**VIRGINIA ELECTRIC AND POWER COMPANY**  
**RICHMOND, VIRGINIA 23261**  
**December 17, 2009**

**VIRGINIA ELECTRIC AND POWER COMPANY**  
**SURRY POWER STATION UNITS 1 AND 2**  
**RESPONSE TO REQUEST FOR ADDITIONAL INFORMATION**  
**NRC GENERIC LETTER 2004-02**  
**POTENTIAL IMPACT OF DEBRIS BLOCKAGE ON EMERGENCY RECIRCULATION**  
**DURING DESIGN BASIS ACCIDENTS AT PRESSURIZED-WATER REACTORS**

**Response to Request for Additional Information**  
**Generic Letter 2004-02**

**VIRGINIA ELECTRIC AND POWER COMPANY  
(DOMINION)  
SURRY POWER STATION UNITS 1 AND 2**

**Figure 3-1: Test Parameters vs. Time for SPS RS Strainer Test**

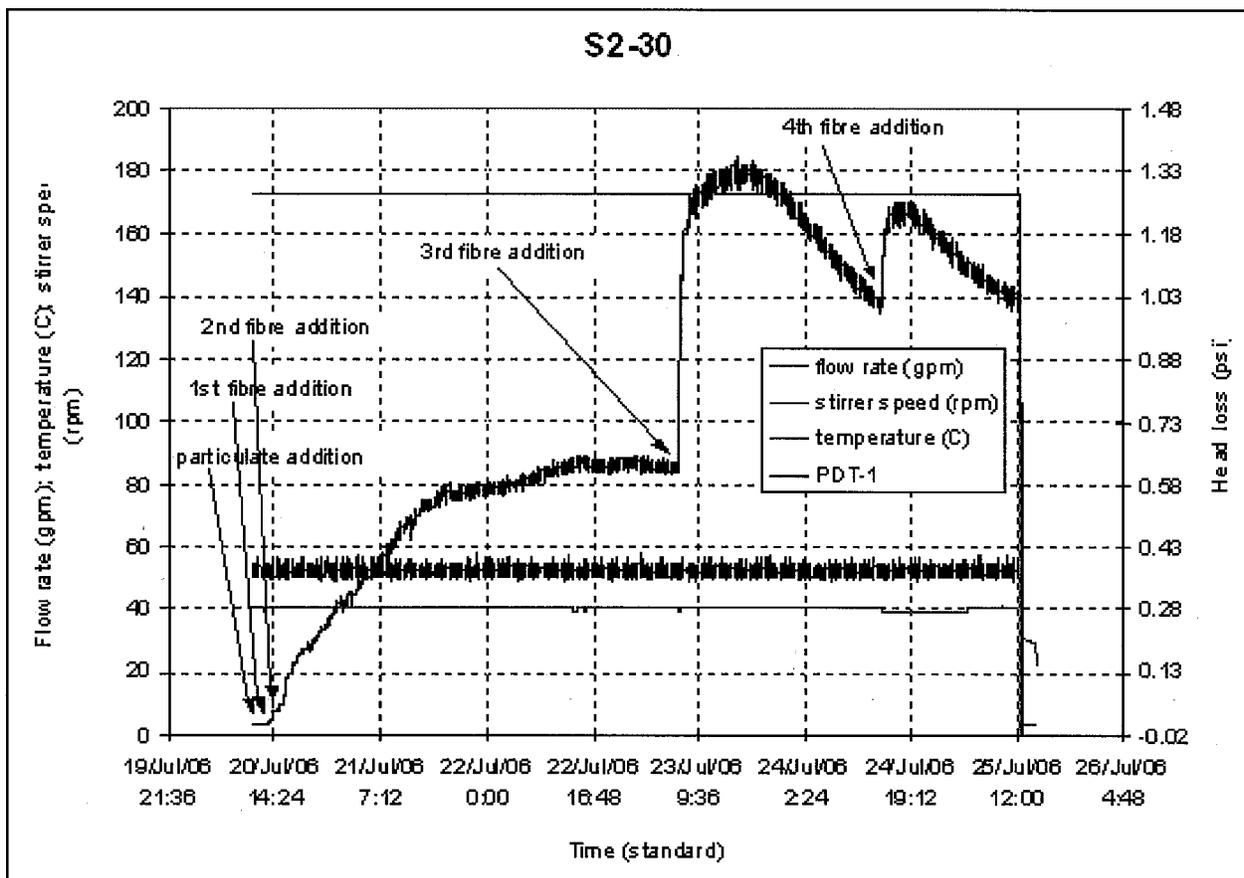
*Please provide additional information that justifies the temperature/viscosity extrapolation of data from test temperatures to predicted loss-of-coolant accident (LOCA) temperatures. Based on recent review of Rig 33 head loss traces for North Anna during the chemical effects audit of that plant, the staff believes that there may not have been "sudden" decreases in measured head loss, but there were anomalous observations of fairly large and relatively fast head loss decreases for qualification tests and other non-qualification tests for North Anna. Flow sweeps were done for some of the tests that seemed to indicate that boreholes did not have a significant influence on the temperature scaling. However, the staff does not consider this information sufficient to conclude that there were no signs of potential bed degradation. Please provide results of evaluation of the cause of the decreases in head loss that occurred during testing.*

The peak measured debris bed head loss in the reduced-scale test occurred four days after the first debris introduction. Using the peak measured debris bed head loss developed in many days in a thin-bed test to qualify short-term pump NPSH criterion has significant conservatism. In addition, this peak head loss occurred while the debris bed was still forming, prior to the time when any potential degradation might possibly

Recirculation Spray - In the reduced-scale test, the flow approach velocity to the strainer surface was calculated to be 0.0047 ft/s. With the test temperature (104°F) and flow condition, the test flow Reynolds number was approximately 3<sup>1</sup>. Hence, it was considered as laminar flow, where the NUREG/CR-6224 correlation shows that debris bed head loss is proportional to fluid viscosity.

As shown in Figure 3-1, the peak RS head loss occurred after the third fiber addition. After that, the head loss was in a slowly decreasing trend for a full day, with no sudden head loss decrease. The fourth fiber addition increased the head loss to 1.2 psi. Again, about 4 hours after the fourth fiber addition, the head loss decreased slowly again. The decreasing trends after the third and the fourth fiber additions were almost parallel, which indicated that the debris bed structure was consistent after the fourth addition.

Figure 3-4: Surry RS Rig 89 Short-term Debris Bed Head Loss

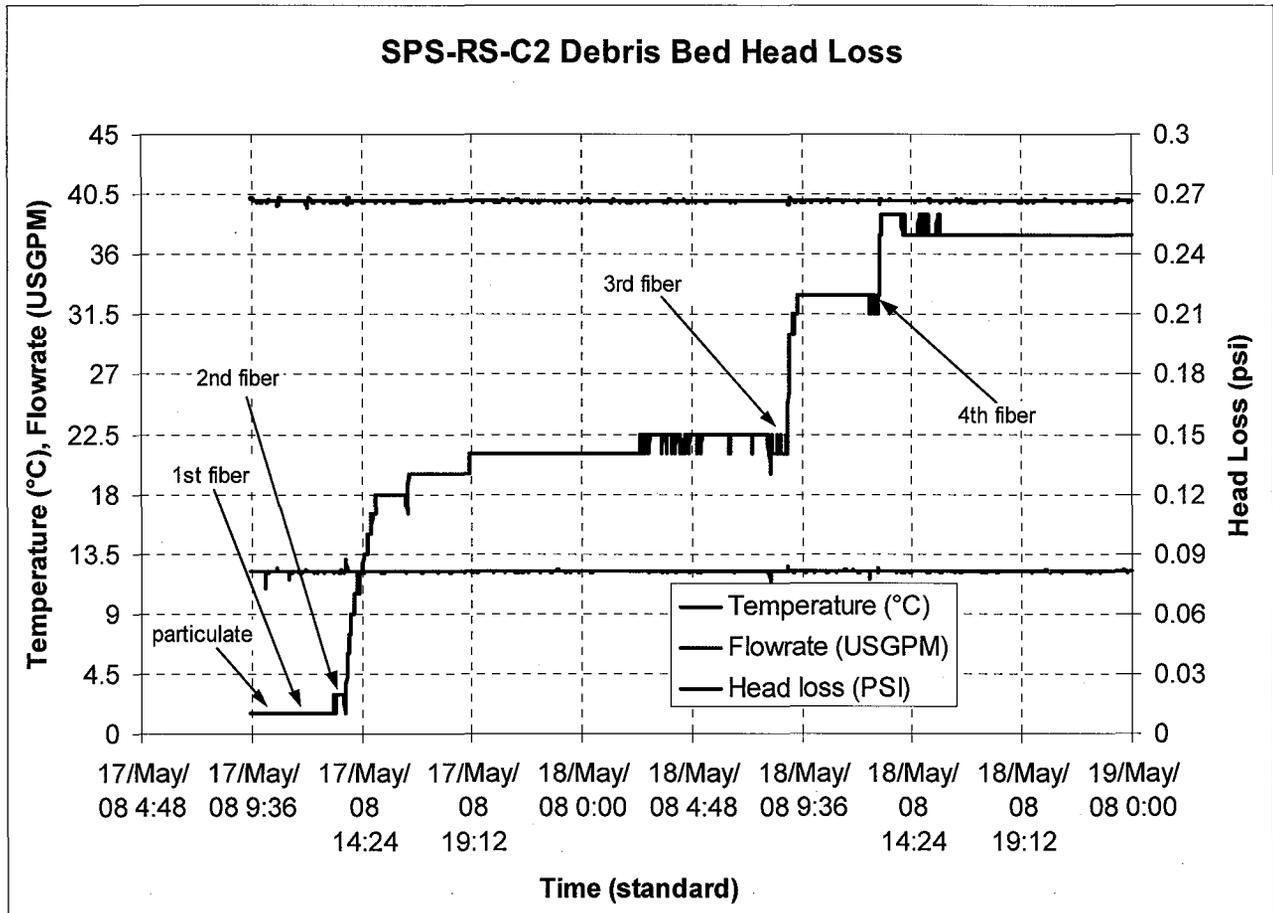
*Please provide an evaluation similar to that provided for North Anna to show that the results of both Rig 33 and Rig 89 tests, and the magnitude of plant-specific conservatisms for Surry, ensure that the strainers will function under design conditions.*

For long-term head loss, since the Rig 89 test temperature was the same as the long-term sump temperature, no viscosity correction was performed. No "sudden" head loss decreases were observed in Rig 89 testing before chemicals were added, as shown in Figure 3-4.

**Figure 5-1: Pressurizer Pressure**  
**1.5 inch Break – Surry Units 1 and 2 SBLOCA Analysis**  
PFN 9 0 0 PRESSURIZER

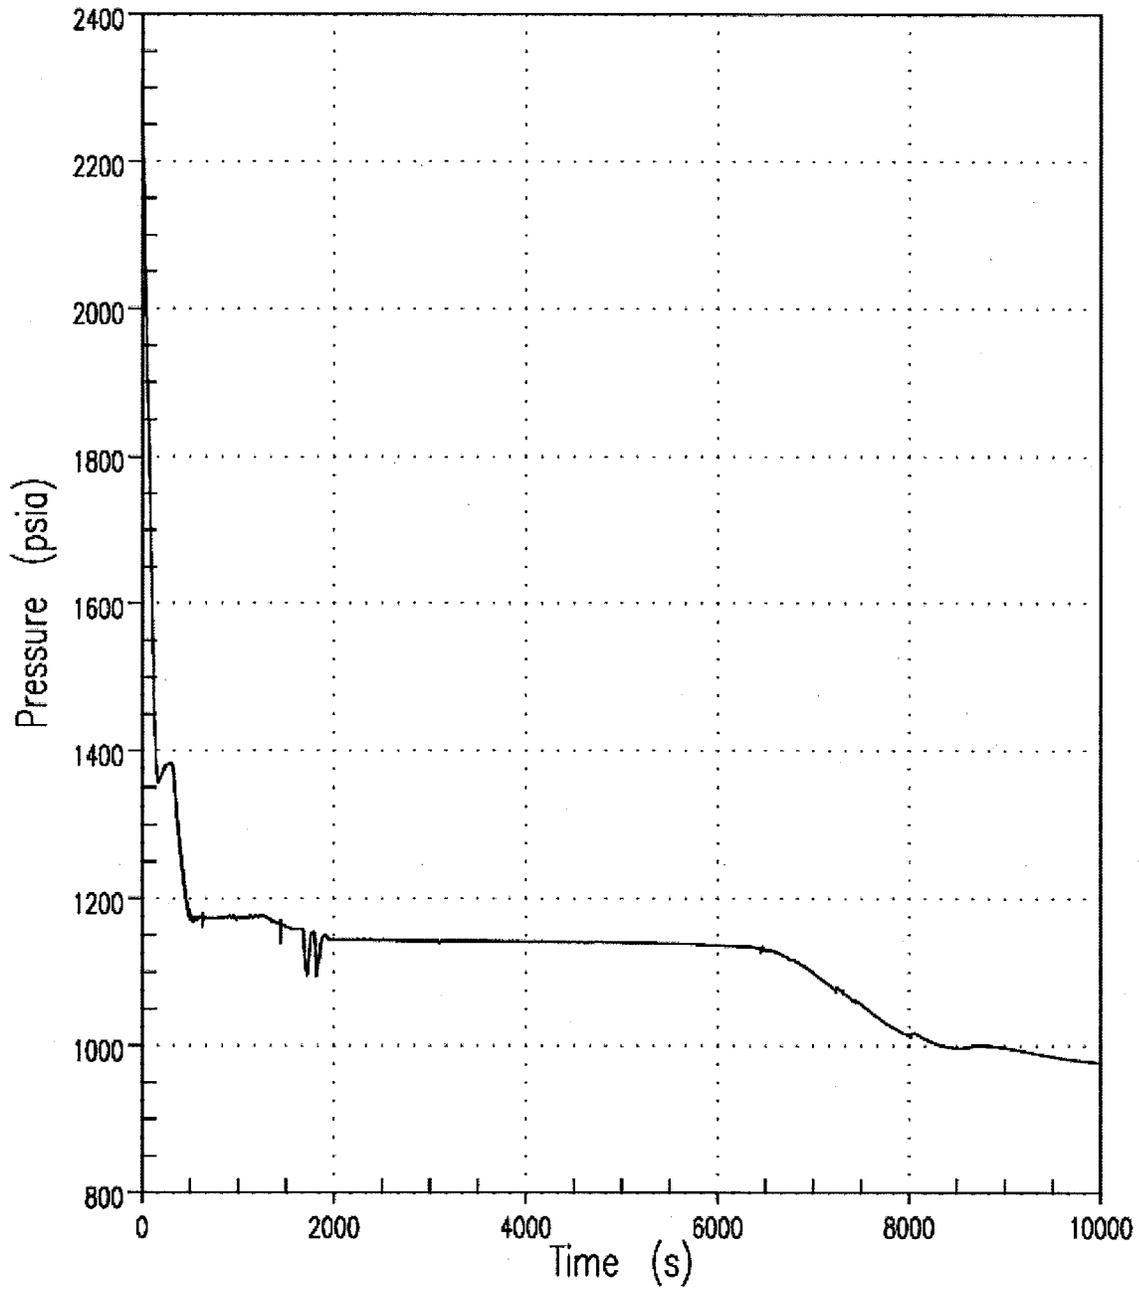
*The minimum strainer submergence was the same for both large-break and small-break loss-of-coolant LOCAs. It was not clear what sources were credited for the minimum level calculation. Please state whether the accumulators are credited for small break LOCA sump level calculations. If the accumulators are credited for small breaks, provide justification for this assumption, or provide the minimum water level if no accumulator volume is credited. Please state whether any RCS volume is credited for the minimum water level calculation. If RCS volume is credited, please provide the volume credited and the assumptions and bases for the credited volume.*

Figures 5-1 through 5-3 illustrate the system response described above for a 1.5" cold leg break. This is a near-limiting break size for RS strainer submergence for two reasons: 1) it provides a small RCS release path for evaluation of ECCS makeup capability and RCS liquid level recovery; and, 2) it results in a long time before reaching the CLS setpoint and RS actuation due to low steaming rates. These figures are from a SBLOCA design basis analysis that is documented in Chapter 14 of the Surry UFSAR. Figure 5-1 shows the pressurizer pressure drop rapidly until it stabilizes with the secondary system and then drops slowly due to the break. In Figure 5-2, the HHSI flow rate equalizes with the RCS break flow rate at about 8000 seconds, when pressurizer pressure is nearly 1000 psia (Figure 5-1). Figure 5-3 shows the total RCS mass approach 100,000 lbm at 8000 seconds. By this time, the RS system has started with an RCS mass contribution to the sump that is larger than the LBLOCA design case. Breaks larger than 1.5" were also evaluated and shown to support this conclusion.

**Figure 6-1: Head Loss Across the Surry LHSI Strainer during the Final AI Additions**

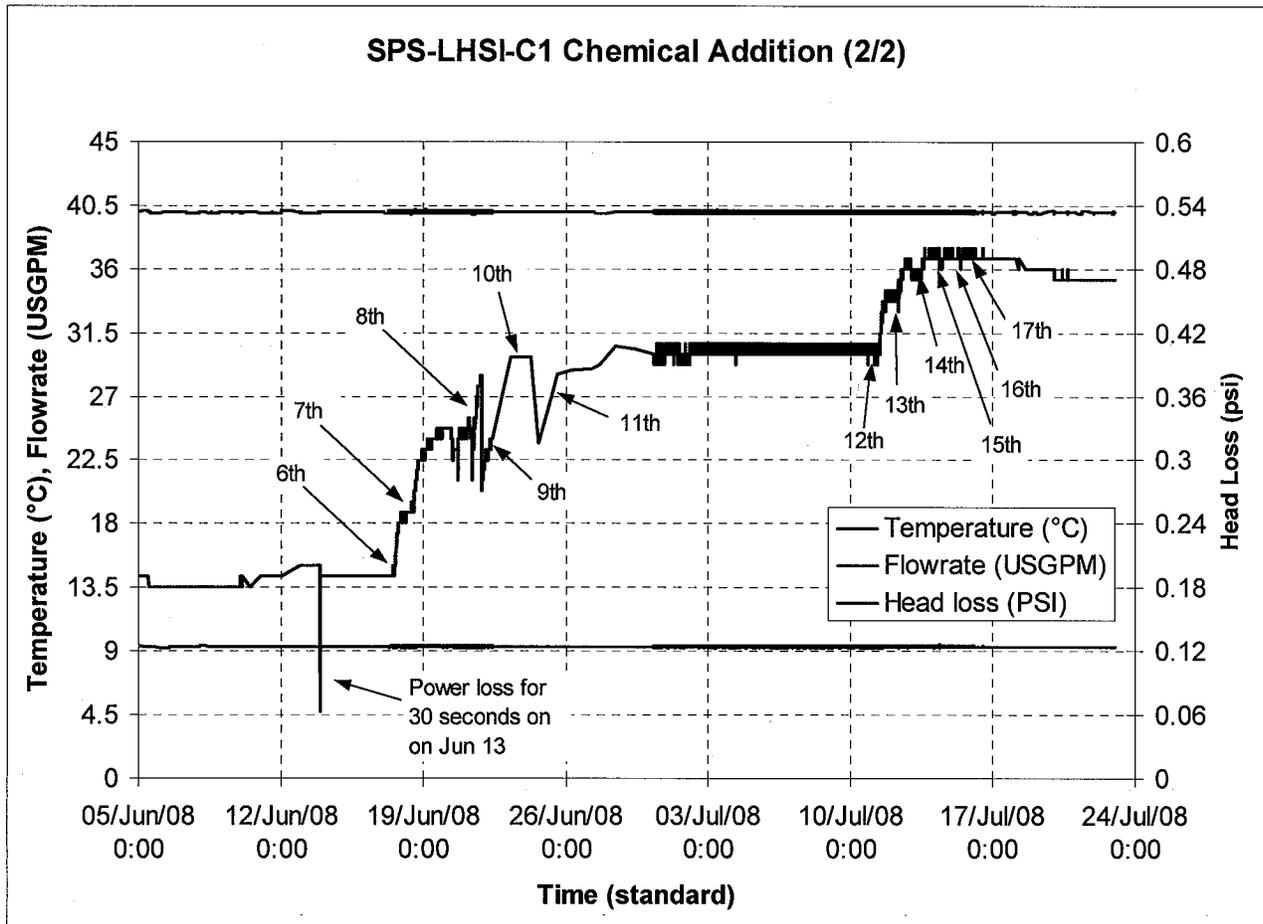
*Please provide an evaluation of the head loss fluctuations that occurred during the low-head safety injection (LHSI) Rig 89 testing between the 7<sup>th</sup> and 10<sup>th</sup> aluminum additions. Also, please explain why these fluctuations do not invalidate any viscosity corrections imposed on the test data.*

The head loss fluctuation between the 7<sup>th</sup> and the 10<sup>th</sup> aluminum additions during the Surry LHSI chemical effects testing is shown in Figure 6-1. As observed in the chemical effects tests, aluminum precipitate tended to deposit on the fiber surface and block the pores of the debris bed. At the time the 7<sup>th</sup> aluminum addition was added, the head loss was only 0.24 psi. Since the head loss was low, the debris bed was not tightly compact and it was fragile. As more aluminum precipitates deposited on the fiber surface, a dynamic process of debris bed cracking and self-repairing was initiated, which resulted in the head loss fluctuation. As more aluminum was added to the test tank, the head loss became higher and the debris bed was more densely compact and there was no fluctuation between the 11<sup>th</sup> and the 15<sup>th</sup> additions.

The peak measured head loss in the Surry LHSI strainer chemical effects test is 0.5 psi at 104°F, which occurred after the 15<sup>th</sup> aluminum addition. The long-term acceptance criterion for debris bed plus chemical effects (after subtracting allowance for analytically determined clean strainer head loss) is 1.41 feet of water at 104°F, which is equivalent to 0.61 psi at 104°F. Since the test temperature and the long-term sump temperature is the same, viscosity correction is not performed.
